Plan Commission

Monday, September 25, 2017

SUBJECT: Recommendation regarding a Site Plan for a new building and parking lot for Midland Plastics INC at the 1400 Block of Richco Court (Parcel WD-L179). Submitted by Midland Plastics INC.

SUBJECT: Recommendation regarding a Site Plan for a building addition for Kay Distributing Co. at 1881 Commerce Drive (Parcel ED-344-102-1). Submitted by Heyrman Construction Co. INC.

South building façade (view from new Richco Court)

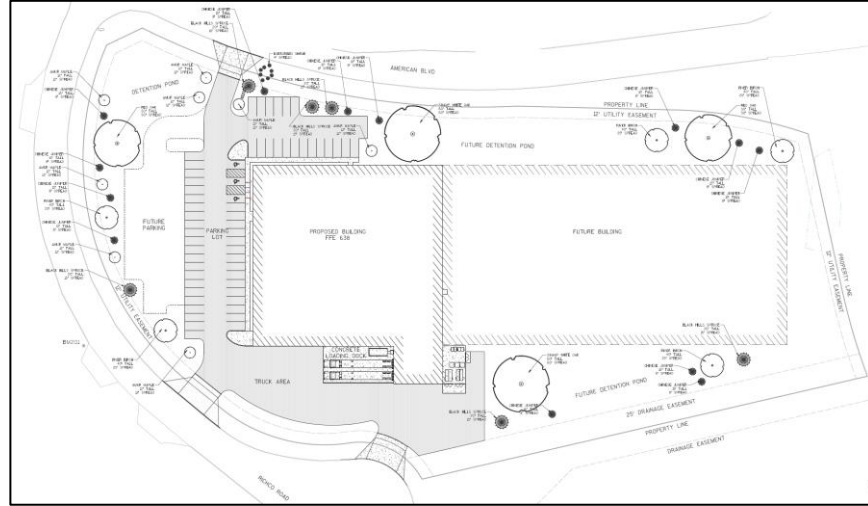
The north end of the building, facing the future Southbridge Road, is not finished with CMU and wide metal wall panels, like what is found on the south and west sides of the building. There is a proposed future addition expected at the north end of the building. The site plan submittal did not indicate a date for any future addition to occur. There are two future stormwater management areas near the north end of the building.

- The area of landscaping between the walkway and the building should be expanded from approximately 3 feet wide to 5 feet wide and vegetated. The present plan does not call out any plants in the area.
- The area of CMU on the south and west sides of the building should be increased from about 4-5 foot high to the height of the doors and windows, if insulated architectural paneling is to be approved as part of the site plan.

C1.0

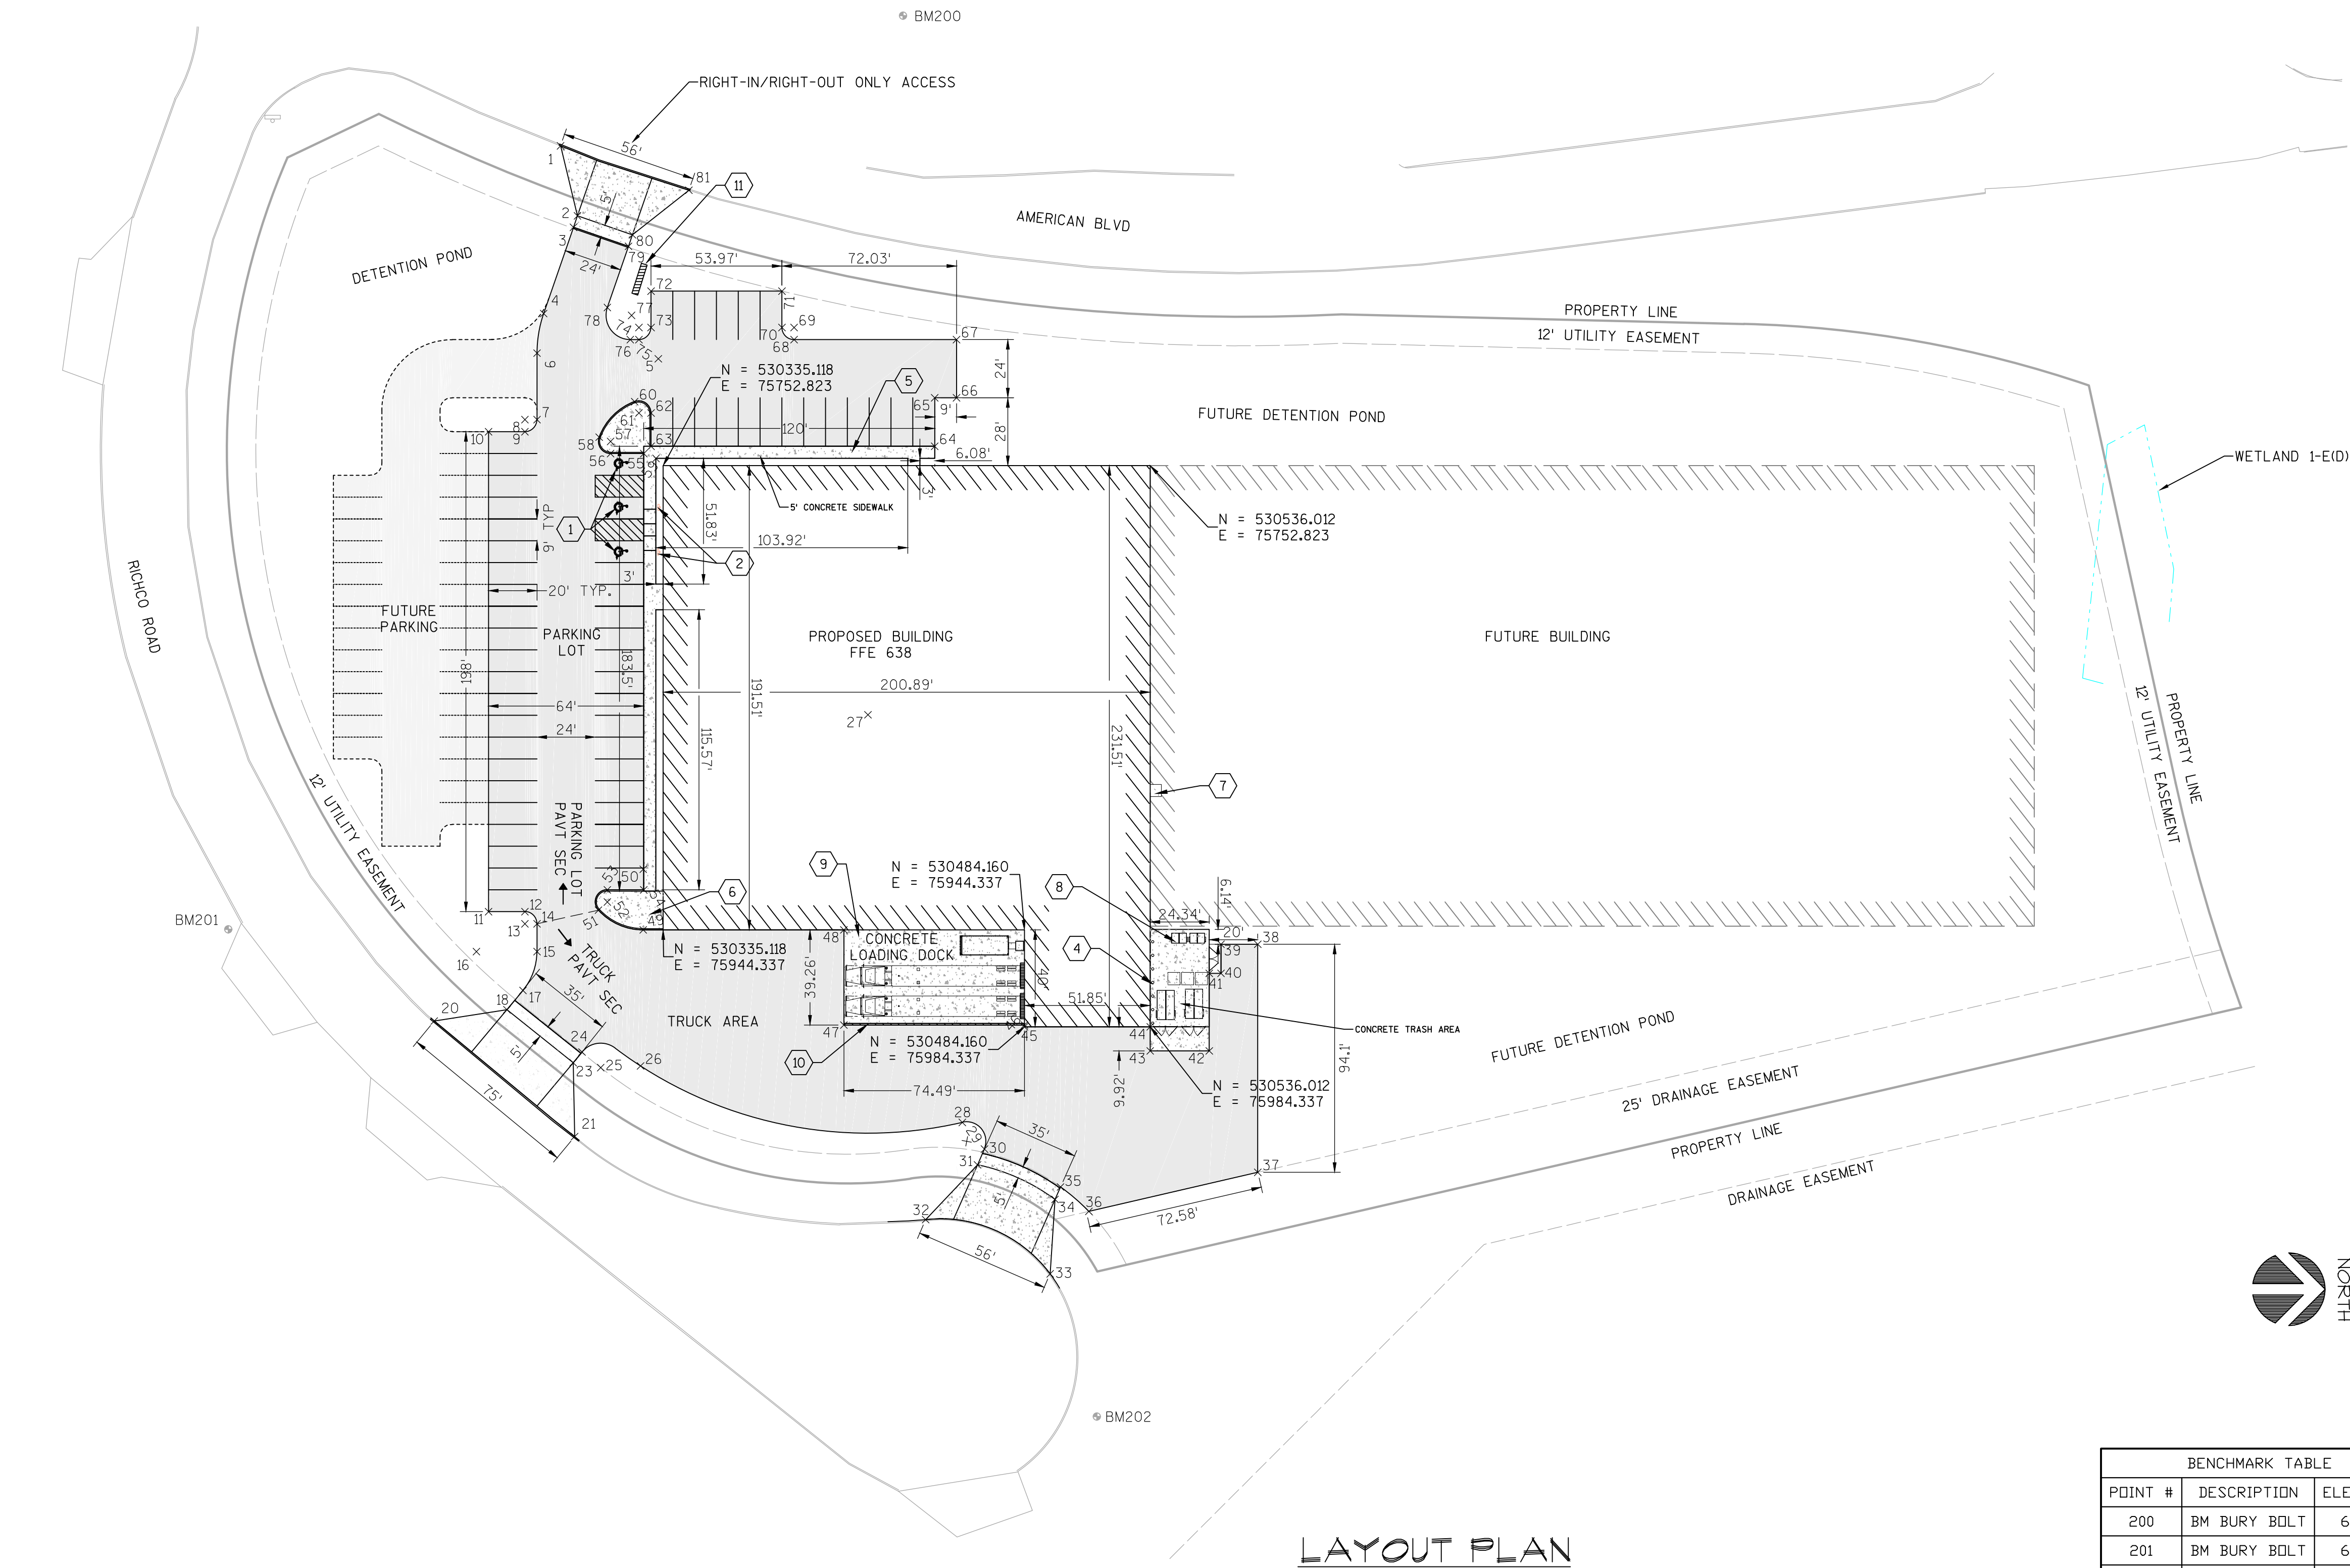
1. Sheet C1.0: List location of project development by street address.
2. Sheet C1.0: List name and mailing address of developer / owner
3. Sheets C2.0-5.0: What is the hatched rectangle off of American Boulevard near the northern driveway approach? Exterior Sign? It is located in the right-of-way which wouldn't be permitted.

SHEET:
C2.0

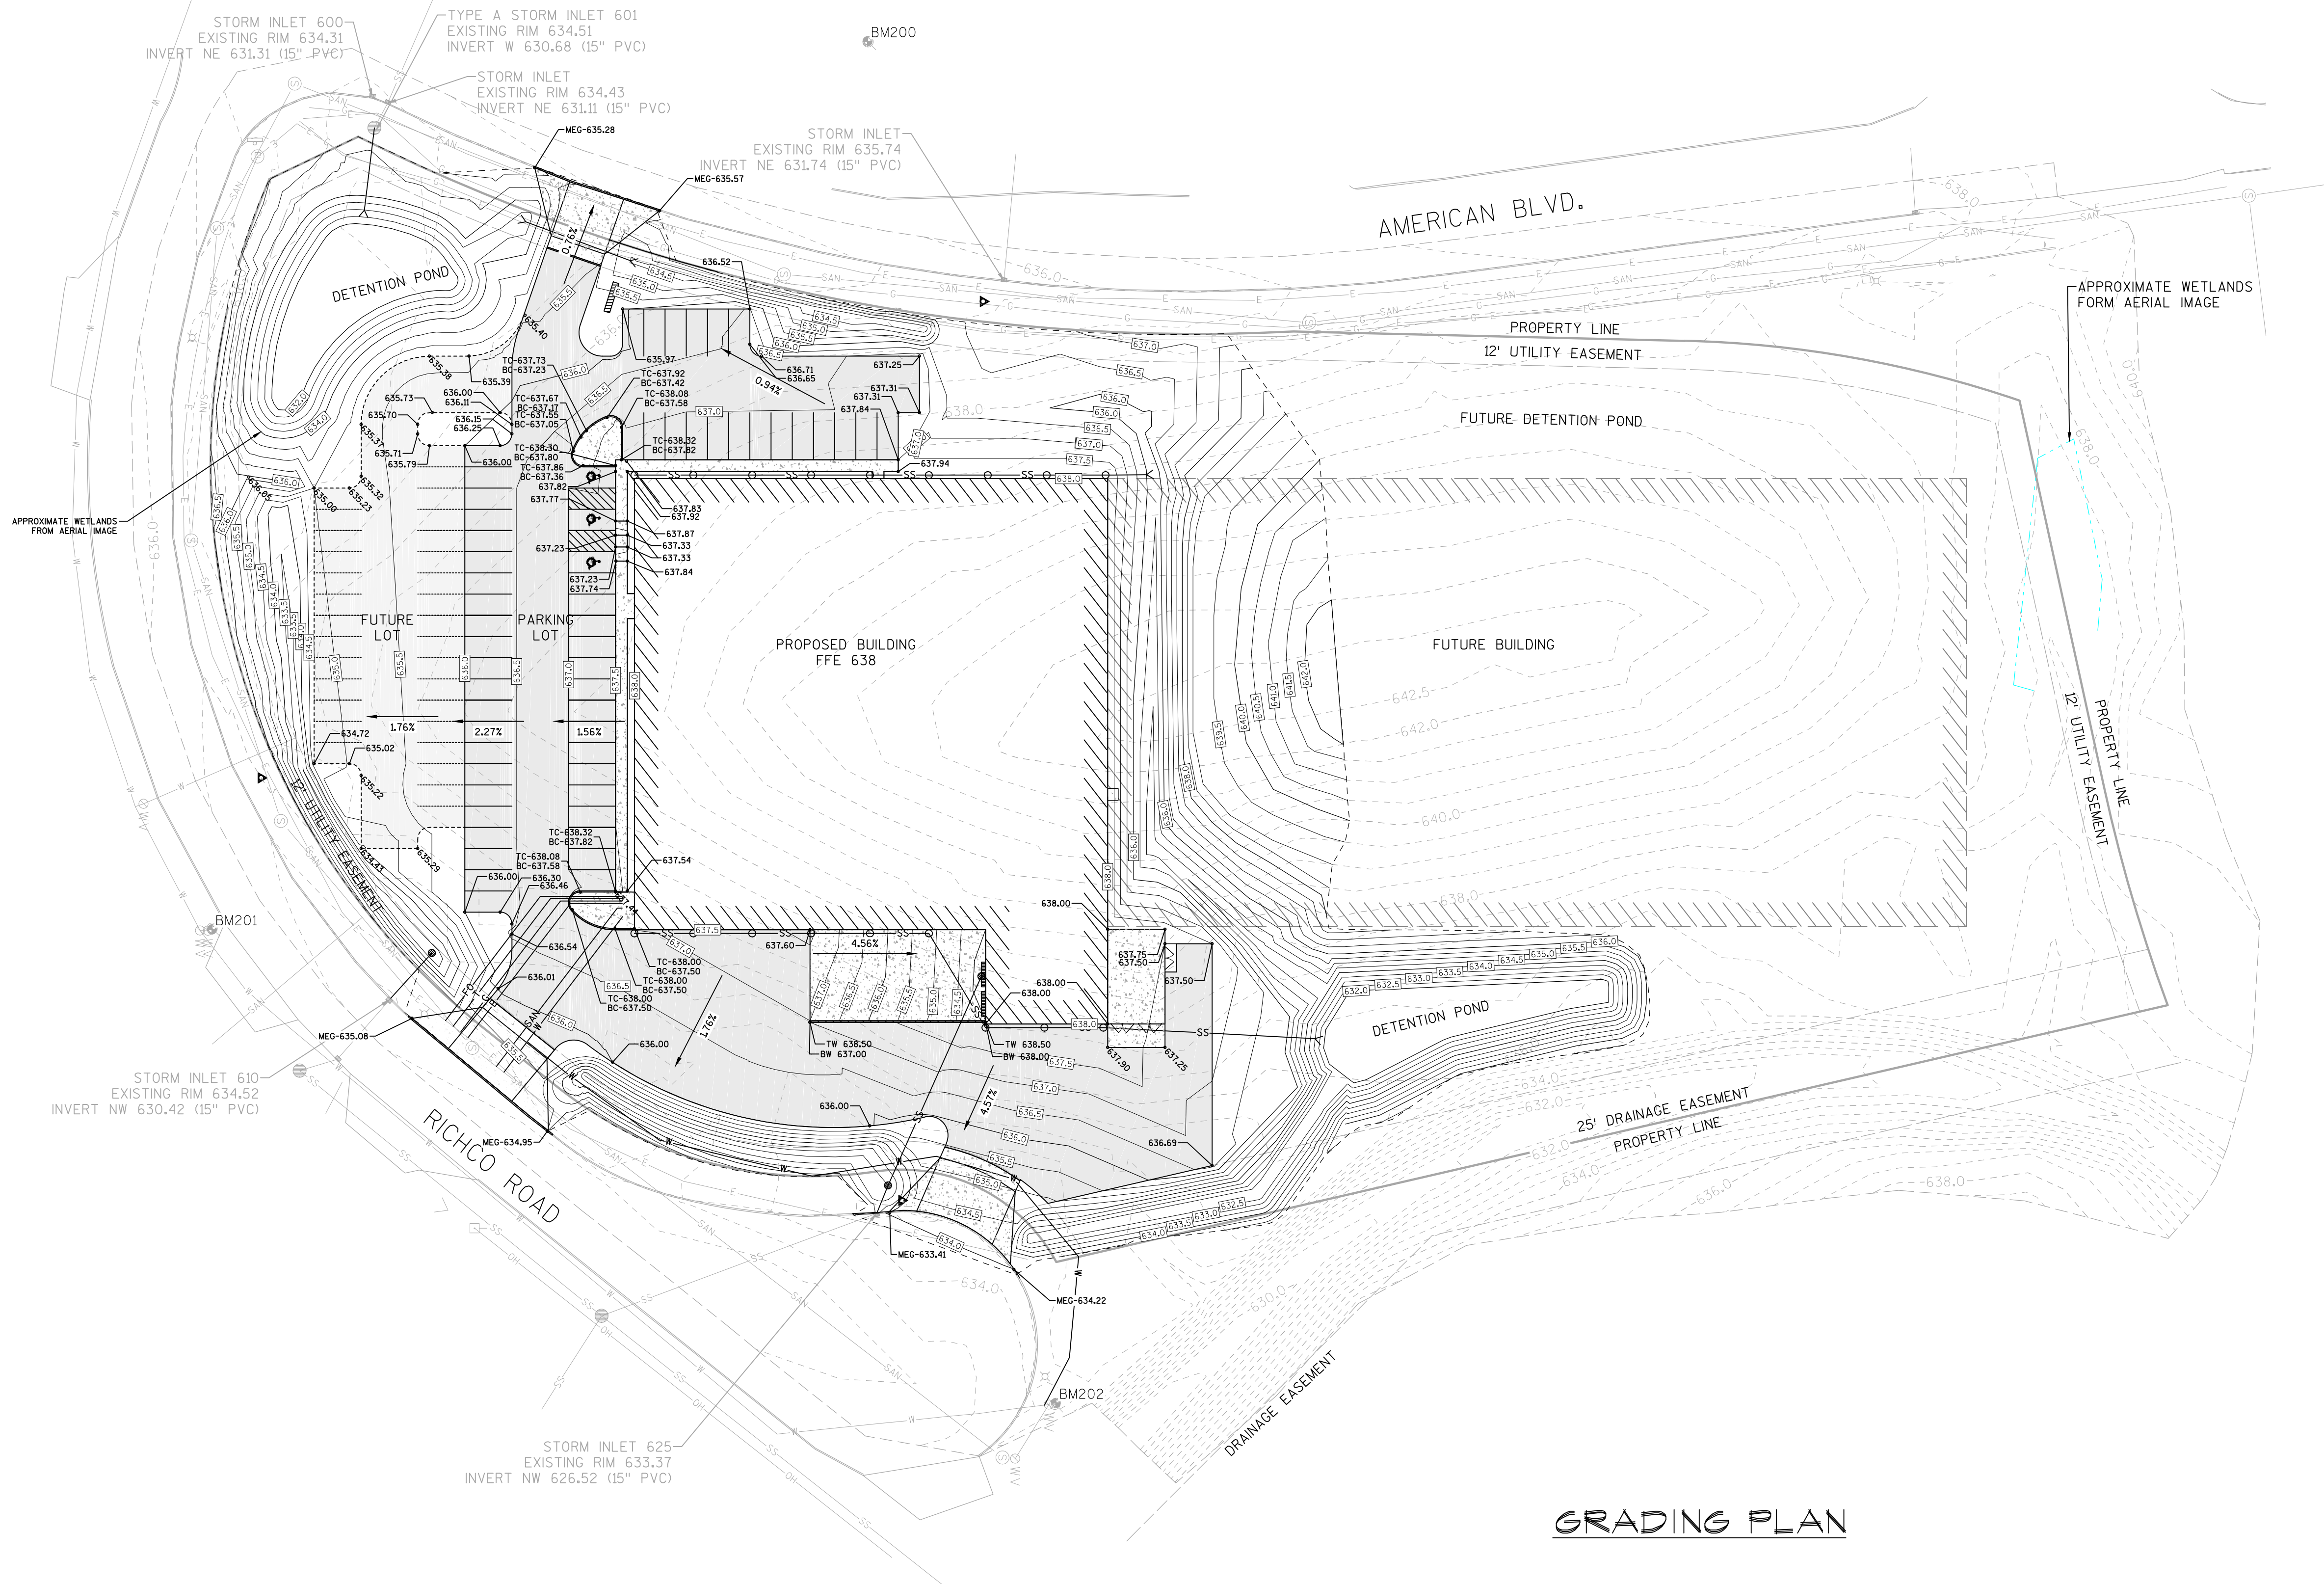
10. Please provide dimensions of all driveway approaches.
11. Sheet C2.0: General note #2 should list sheet C4.0 not XX.X
12. Sheet C2.0: Based of the proposed parking stall count (not including the future lot) 3 accessible parking stalls will be required, one of which must be van accessible. If the future parking lot is considered, more stalls may be required.
